Meeting: 01/27/2020

COA STAFF REPORT

721 W First St.

Meeting: 01/27/2020

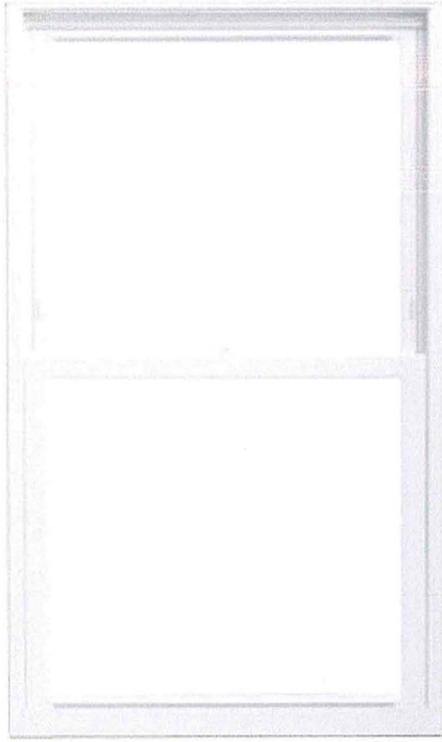
Hardie board to replace current vinyl siding.

Vinyl windows to
replace metal windows

It is staff's opinion that the project is partially in conformance with the design guidelines. The replacement of the vinyl siding with cement siding is in conformance with the guidelines. The replacement of the windows is not in conformance with the guidelines. The removal of the porch and rebuilding of the porch may be in conformance with the guidelines depending on the design of the rebuilt porch. The rebuilt porch should match the original design of the porch in order to be in compliance with the guidelines.

Board should ask about the condition of the existing windows and if the original wood siding is located underneath the vinyl siding. If the original wood siding is under the vinyl siding, the board should ask if it can be repaired. The board should ask about the use of wood or aluminum clad windows instead of the vinyl windows.

demolish shed

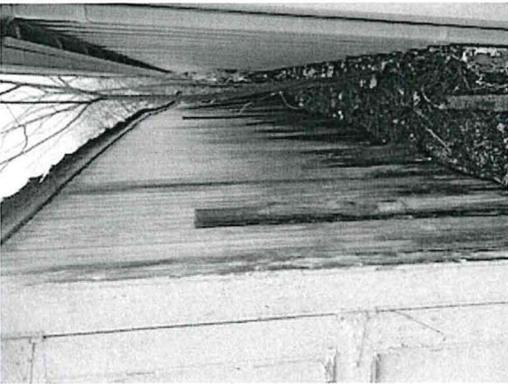
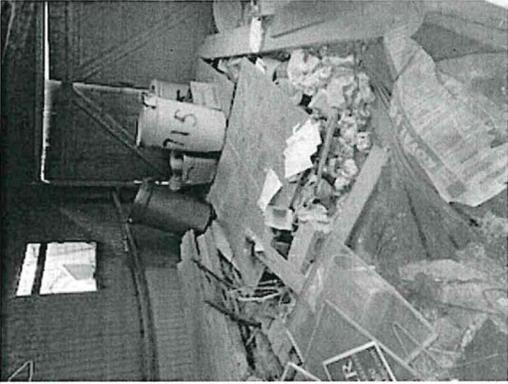
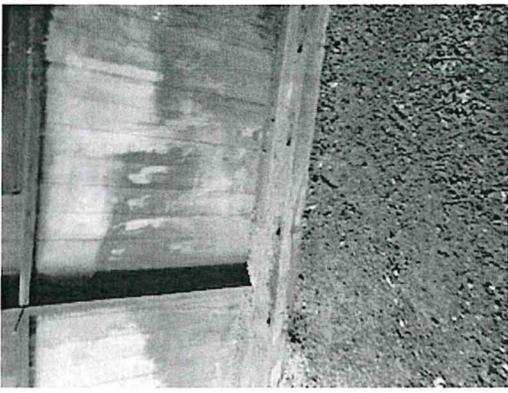
It is staff's opinion that the project may be in conformance with the design guidelines. The state of deterioration of the exterior materials is apparent within the photos provided by the applicant however there is no evidence that the structural elements have been compromised. The removal of this structure would be detrimental to the character of the district.

Board should ask about alternatives to demolition and if this structure could be resided in order to retain it.
